ADDENDUM NO. 1
May 31, 2023

2023 RECONSTRUCT TERMINAL BUILDING
AIP No. 3-27-0025-20-2023
SKY HARBOR AIRPORT
DULUTH, MN

SEH No. DULAI 172133

C2.20

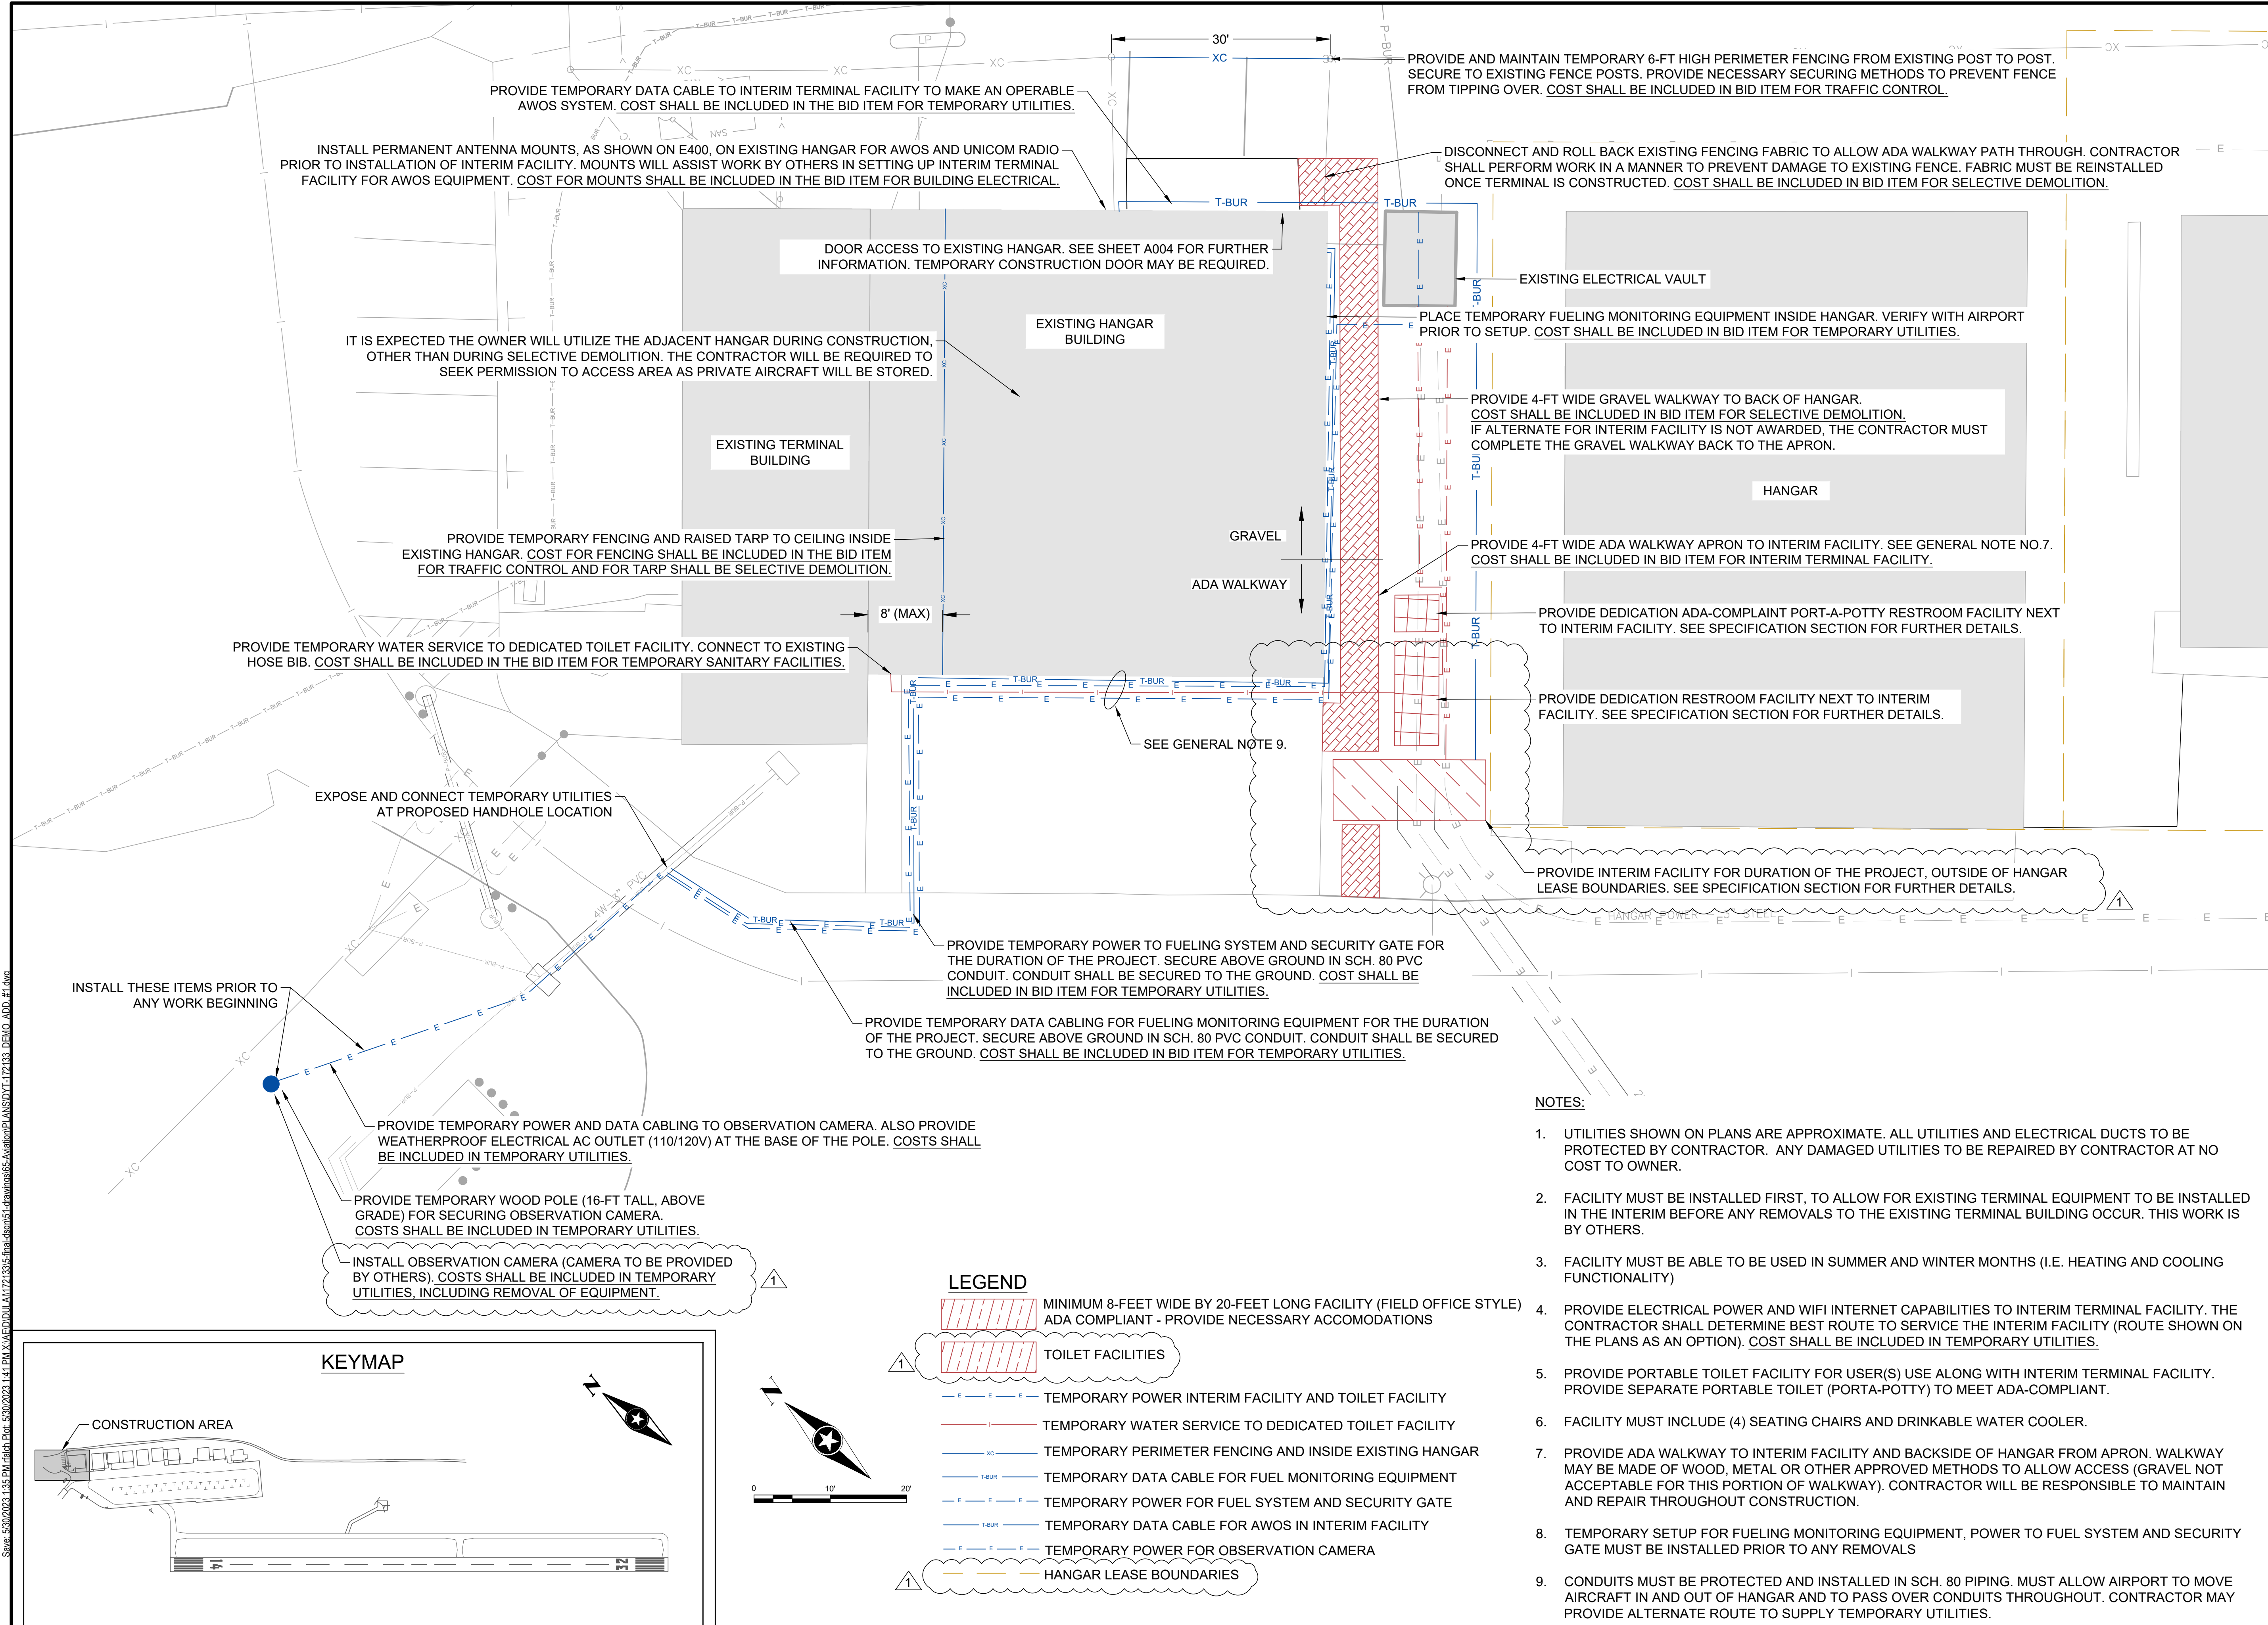
14. Drawing C2.20 – Interim Terminal Facility and Temporary Setup, DELETE in its entirety and REPLACE with the attached revised drawing.
 - Clarified placement of temporary facilities, outside of tenant lease boundaries.

- Added language for contractor to install and remove observation camera.
15. DELETE the following drawings and REPLACE in their entirety with the attached revised drawings:

E SECTION THROUGH CANOPY
S504 ORIGINAL SCALE: 1/2" = 1'-0"

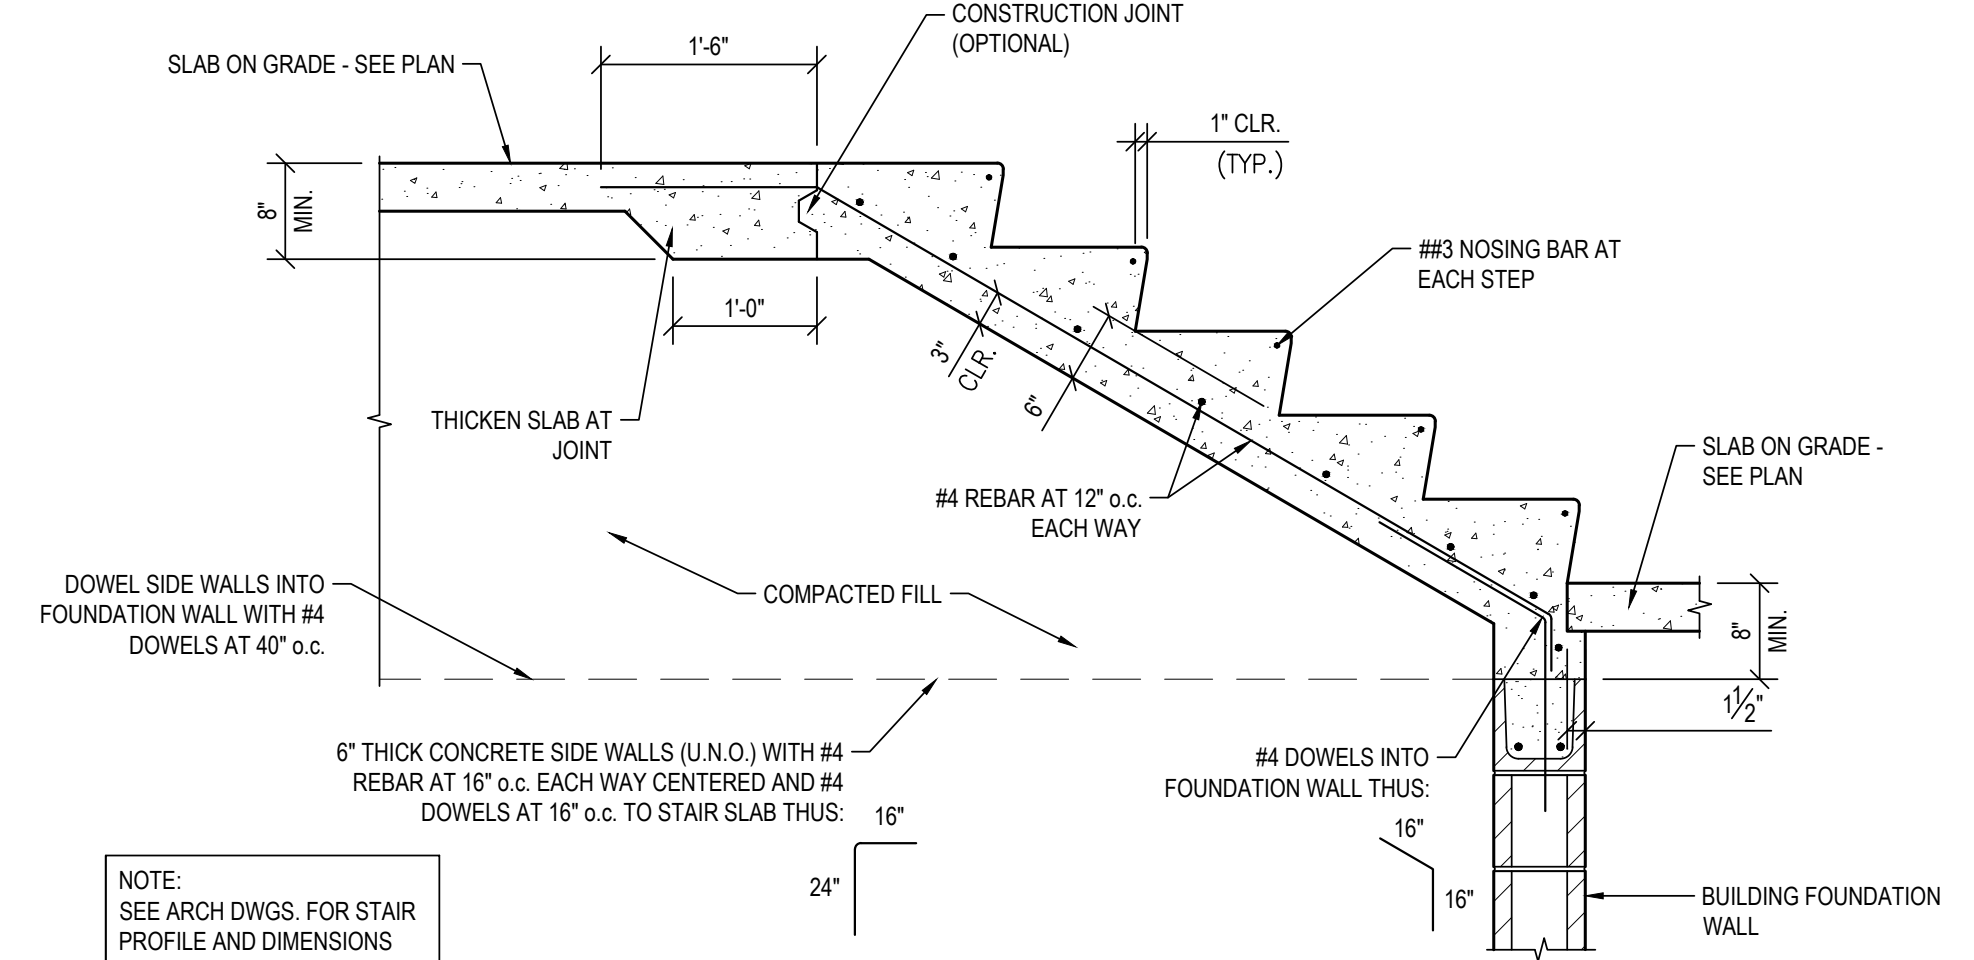
ADDED SHEET AND REVISED SECTION THROUGH CANOPY
